Proposed Milton Quarry East Extension
JART COMMENT SUMMARY TABLE – Geology and Water Resources

JART Comments (December, 2022)	Reference	Source of Comment	Applicant Response (January 2023)	JART Response
Report/Date: Geology and Water Resources Assessment Report December 2021		Author: GHD

Groundwater Elevation Contour Plots

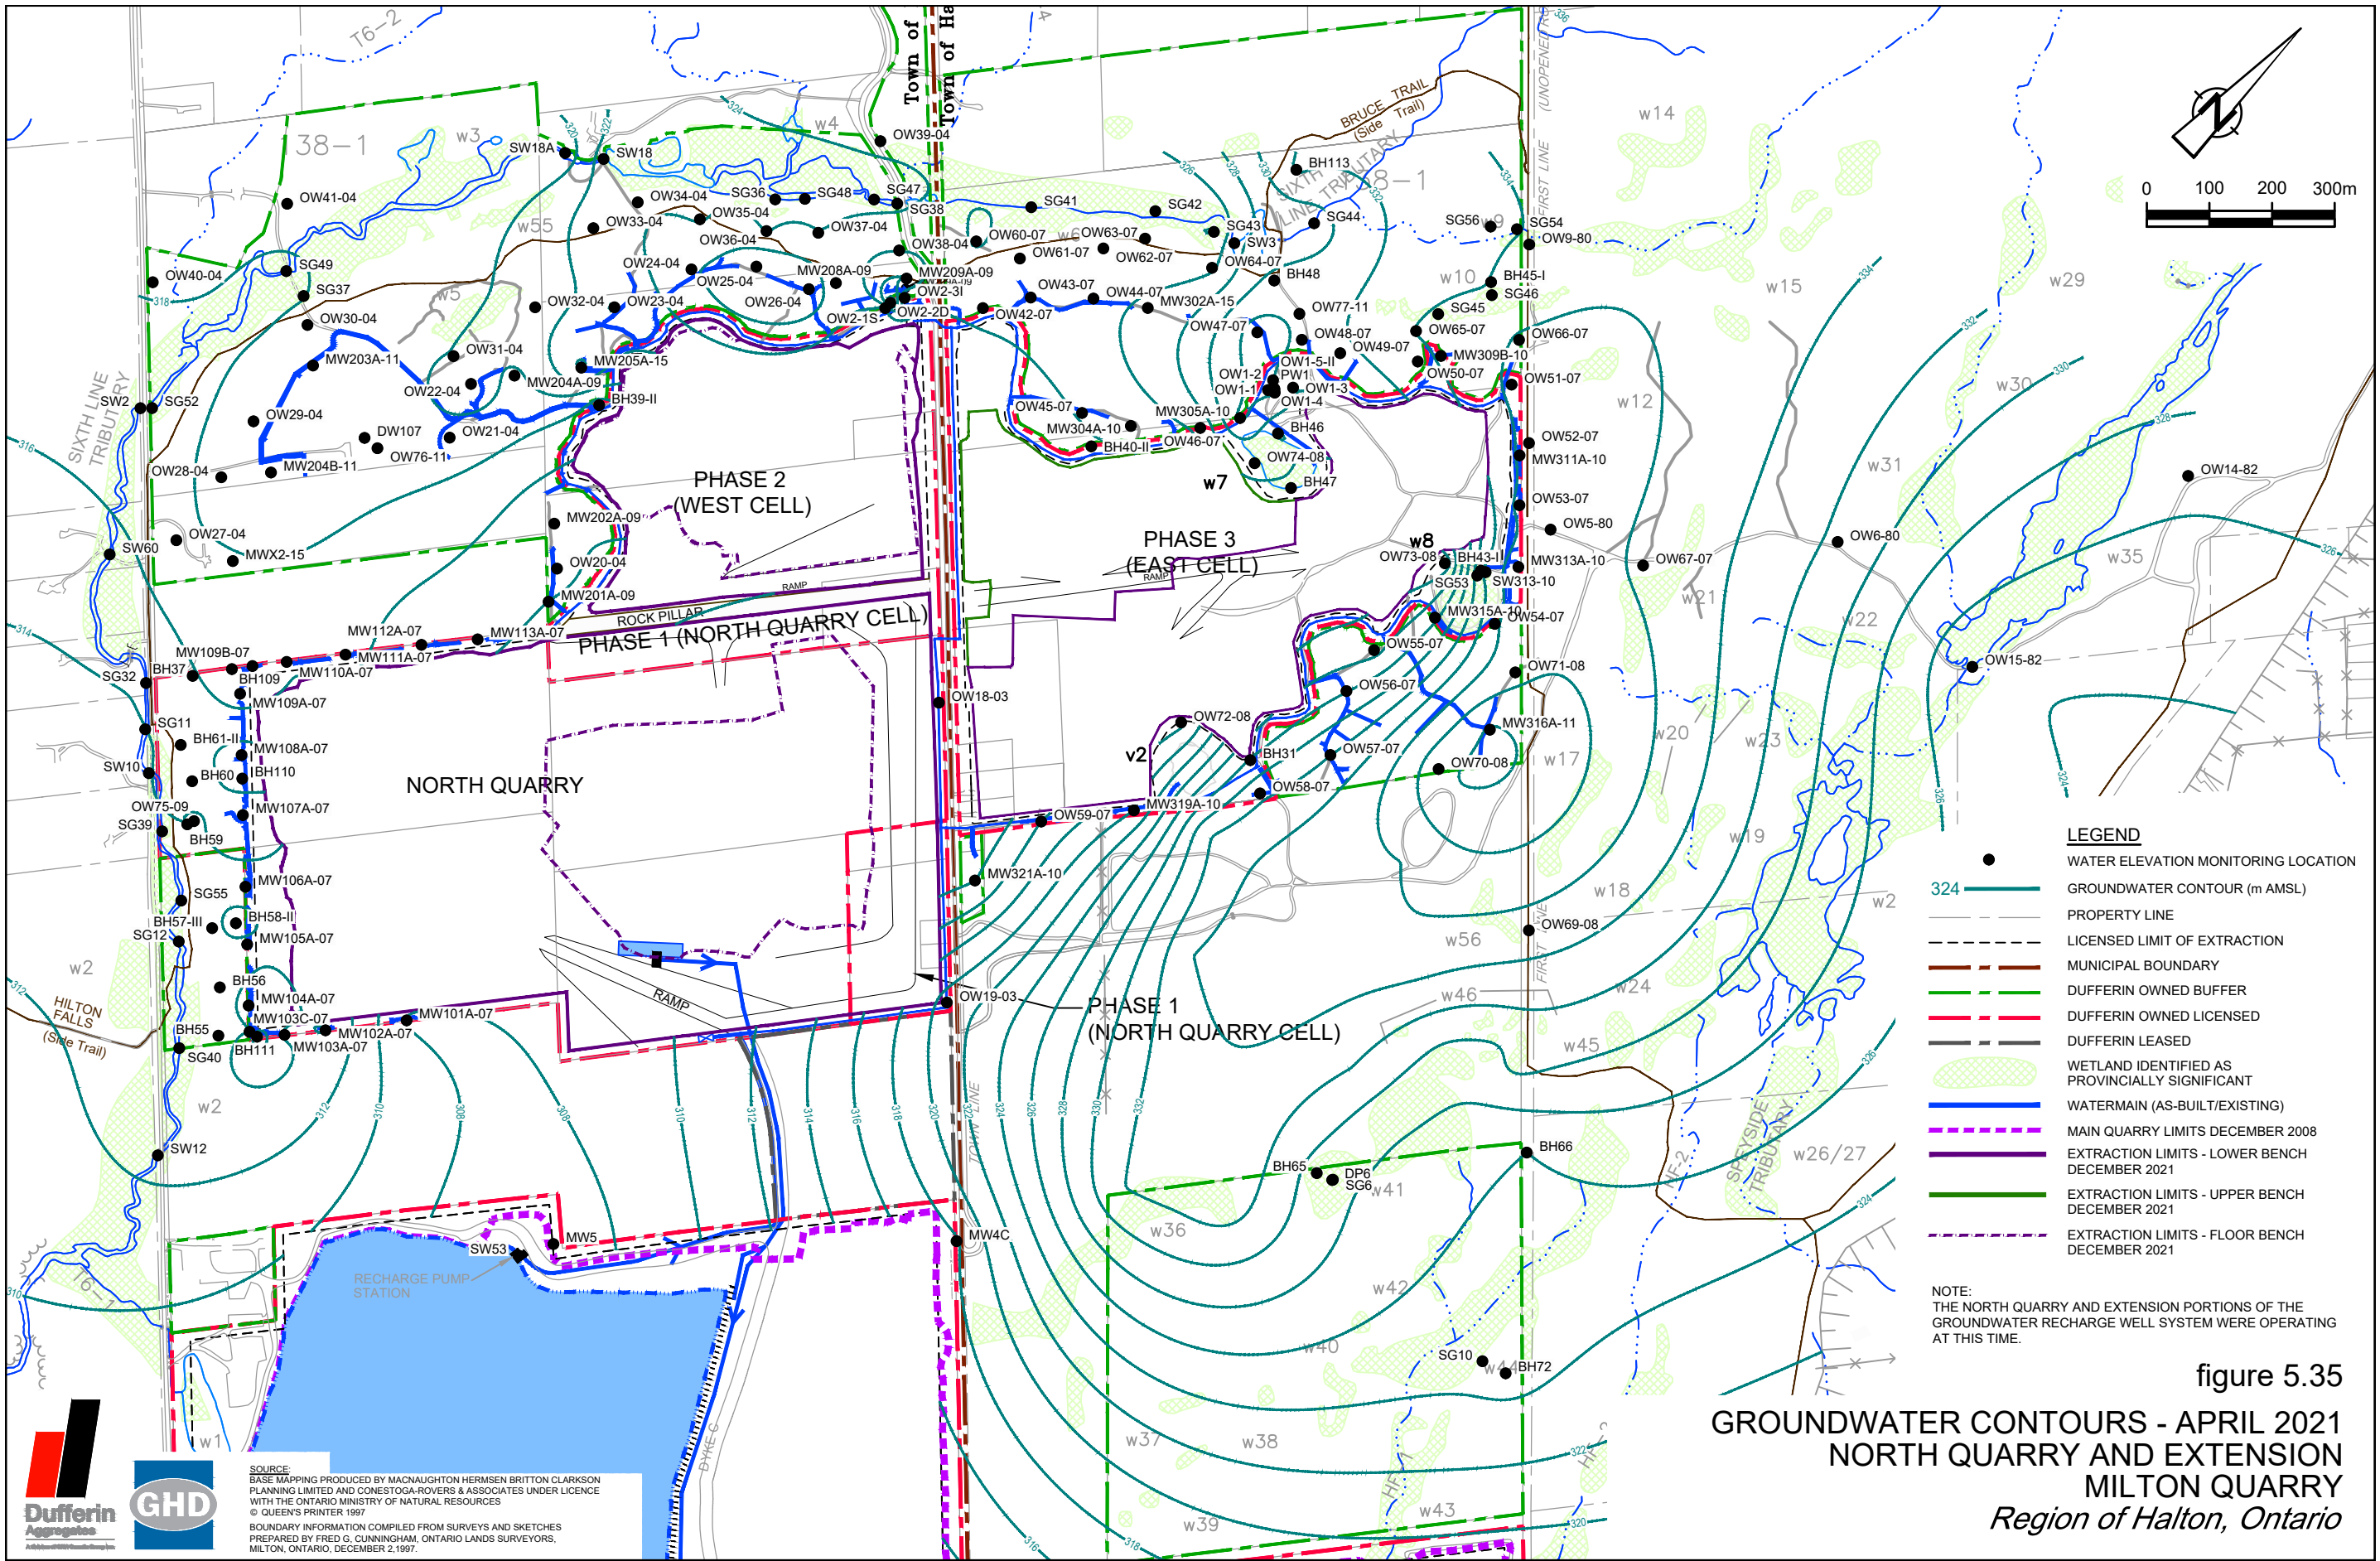
8.	<p>There should be a discussion of the inter-relationship between surface water and groundwater divides and the impact of changing groundwater divides may have on surface water features.</p> <p>Figure 2.8 shows groundwater elevation contours from which regional groundwater flow can be inferred. Interpreted flow directions are not shown on this figure. As noted on Figure 2.8, groundwater elevations <i>'are from MOE drilling records extracted for 2000 GWRA'</i>. An updated version of this figure should be included with recent on-site groundwater elevations to reflect current conditions and the extent of the current zone of influence of the existing quarry. Current groundwater elevation contours are provided for the MQEE area in Figures 6.1, 6.2, 6.3 and 6.4.</p>	Page 11, Section 2.5 Regional Hydrogeology Above Escarpment, 1 st paragraph (Issues list item 1.2)	Norbert M. Woerns	<p>The proposed MQEE will not change groundwater divides. The proposed mitigation measures will support groundwater levels and hence maintain the existing groundwater flow patterns and divides.</p> <p>The groundwater surface water interactions in the MQEE area are described in detail in GWRA Section 6.8.</p> <p>The regional groundwater flow system shown on Figure 2.8 is provided to show the overall regional groundwater flow context. Since the derivation of the dataset, the groundwater flow directions and divides have not been influenced beyond the hydrogeologic boundaries for the Existing Quarry (i.e. the Sixth Line Tributary, North Quarry, Main Quarry, and Niagara Escarpment).</p> <p>Within these hydrogeologic boundaries the groundwater divides have been maintained by the Existing Quarry mitigation measures. Attachment</p>

JART Comments (December, 2022)	Reference	Source of Comment	Applicant Response (January 2023)	JART Response
Report/Date: Geology and Water Resources Assessment Report December 2021			Author: GHD		
				A includes 3 figures from the Annual Monitoring Reports corresponding to the dates of Figures 6.1, 6.2, and 6.3 (i.e., April 2020, October 2020, and April 2021) referenced in the comment. These figures illustrate the overall groundwater flow regime is maintained within the hydrogeologic boundaries of the Existing Quarry. Updating of Figure 2.8 of the GWRA is not warranted and would only change in the local area within the Existing Quarry hydrogeologic boundaries where the remaining areas of Amabel Aquifer are supported by the mitigation measures. The groundwater flow conditions in the local area of interest are better reflected on the MQEE area maps (GWRA figures referenced in the comment) or the Existing Quarry figures from the 2021 Annual Water Monitoring Report (GHD, March 2022) which are included in Attachment A for convenience.

GWRA Figure 5.2Rev1

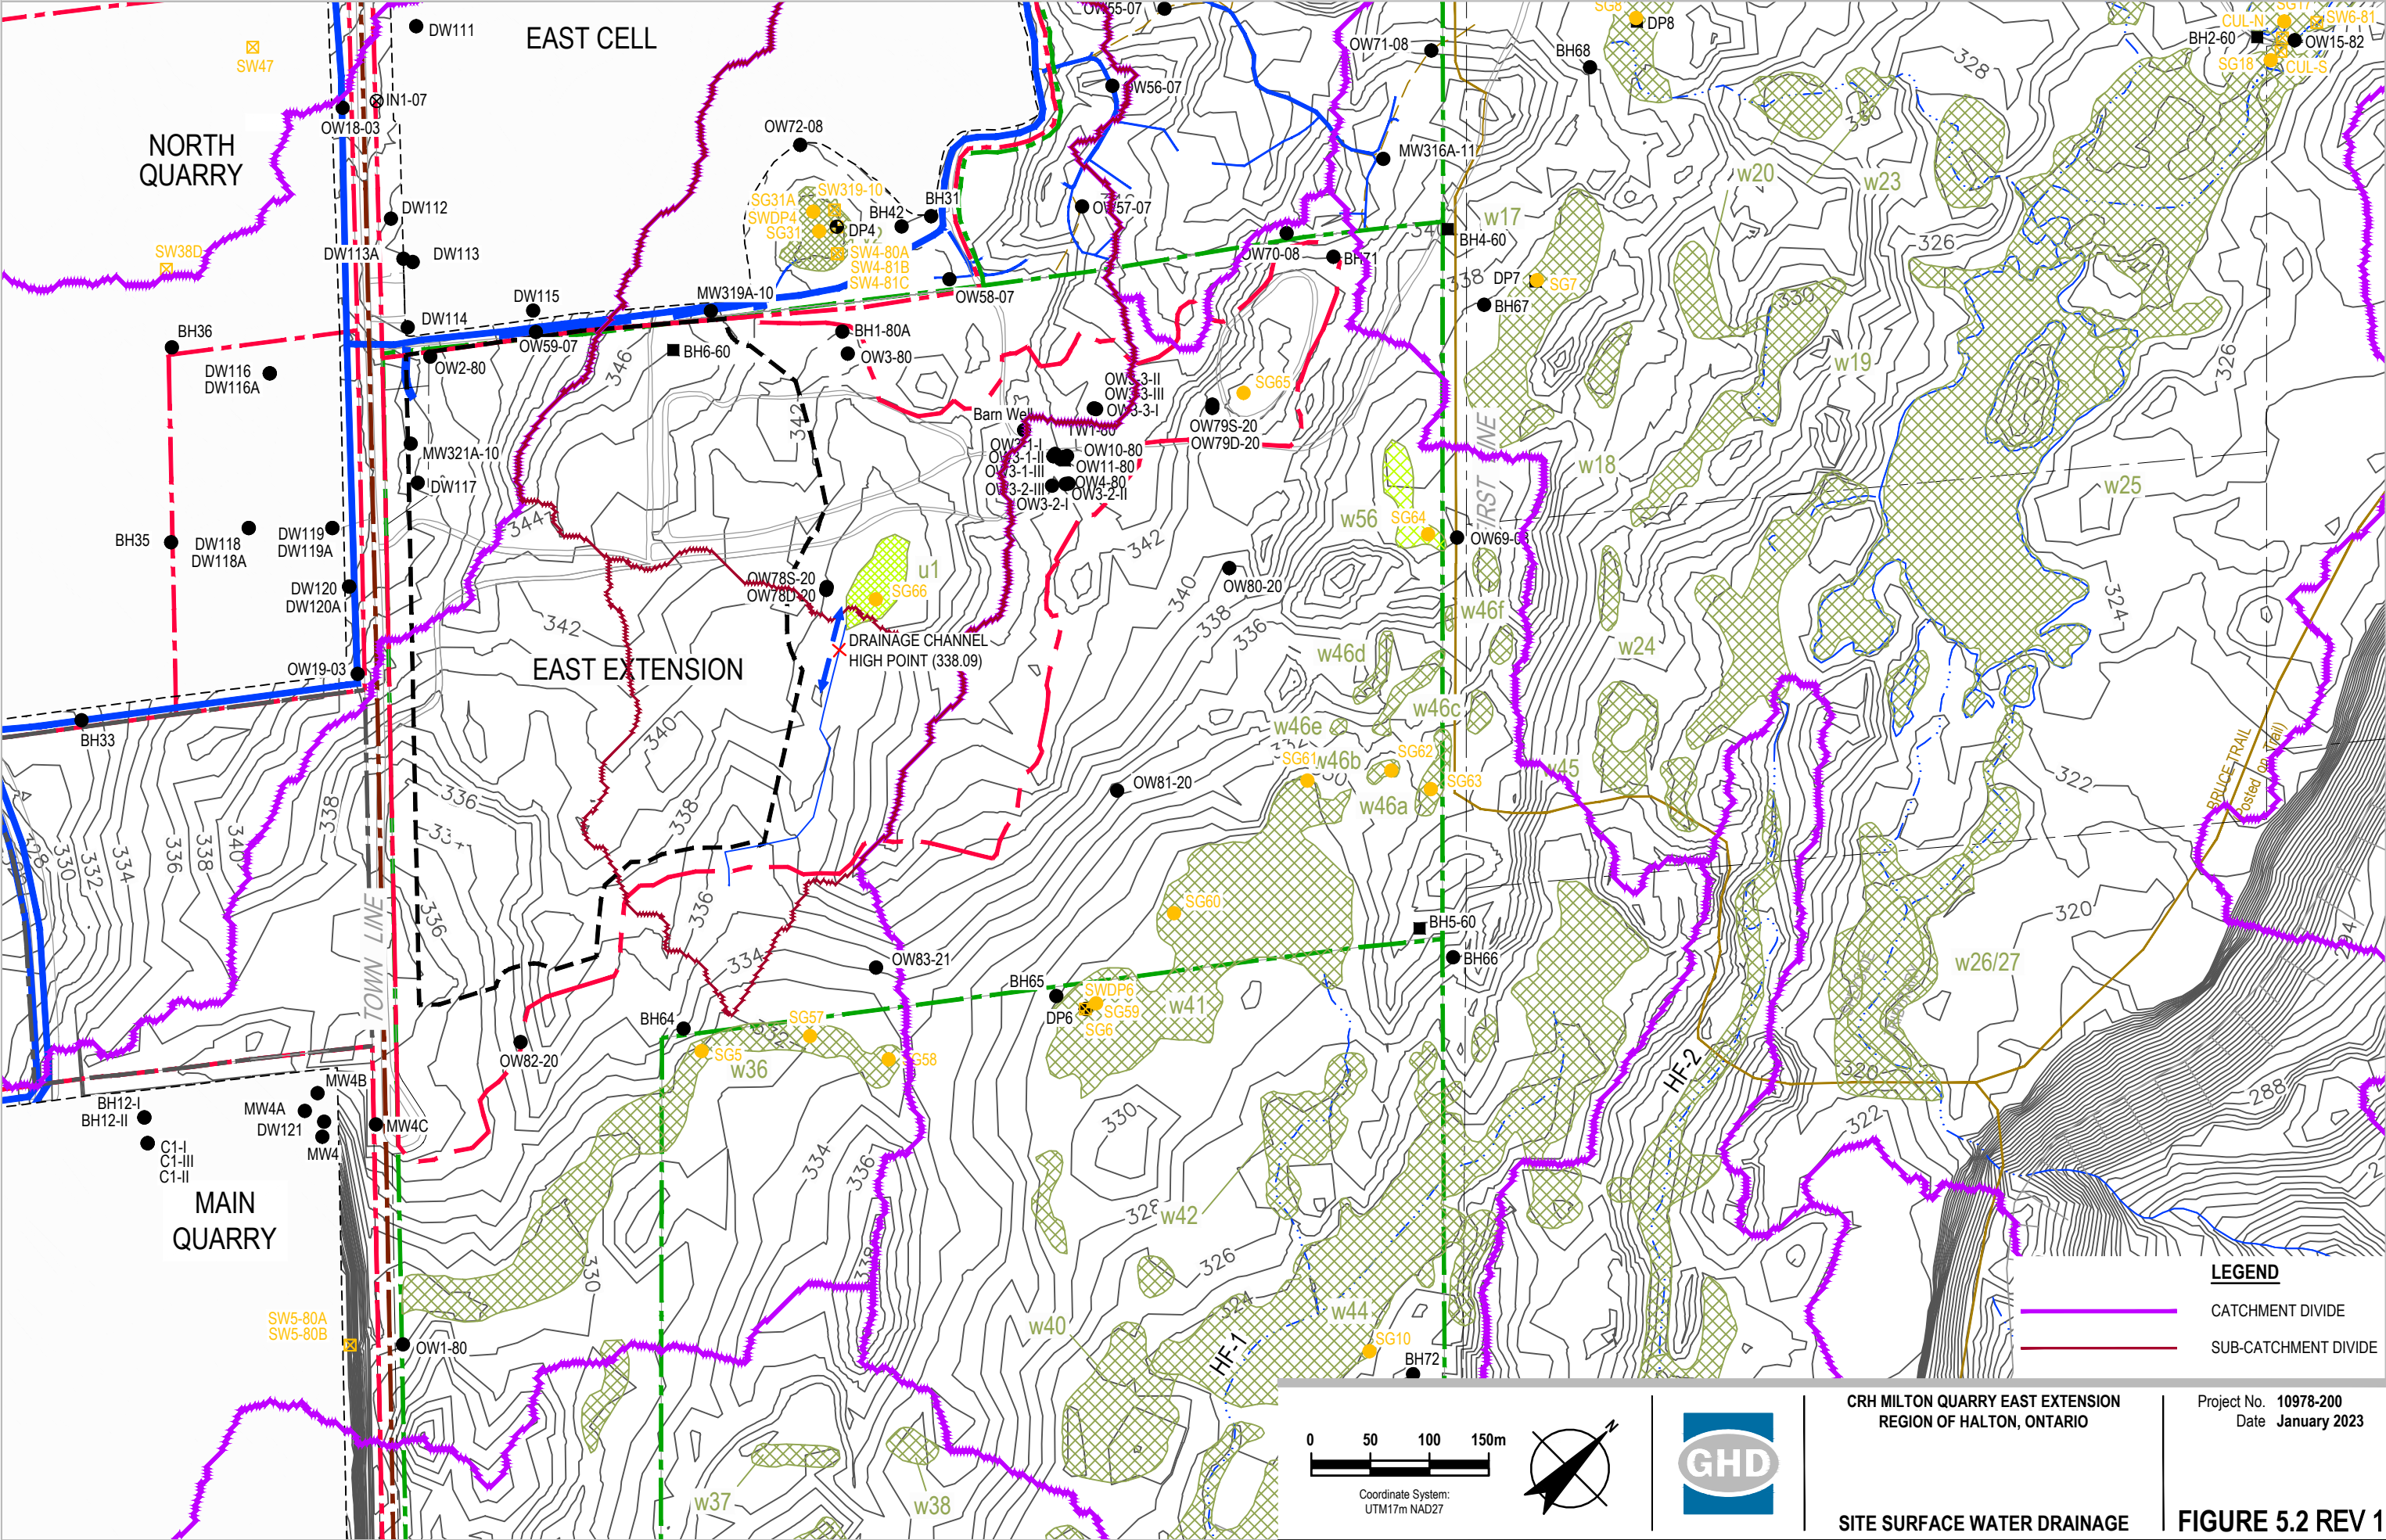
19.	States that tributary is labeled HS-1 on Figure 5-2, but that label is not on this figure. In general Figure 5-2 is difficult to read (e.g. HS-2), and labels are floating in space (e.g. W42, W40). Suggest this figure is clarified to be easier to read.	Section 5.3 Hilton Falls Reservoir Tributary	CH	The labels for HF-1 and HF-2 are behind the wetland layer and will be brought to the front in any future mapping. Labels for wetlands will also be reviewed, and leader lines added where necessary. For clarity, we have provided a revised version of Figure 5-2 in Attachment B.
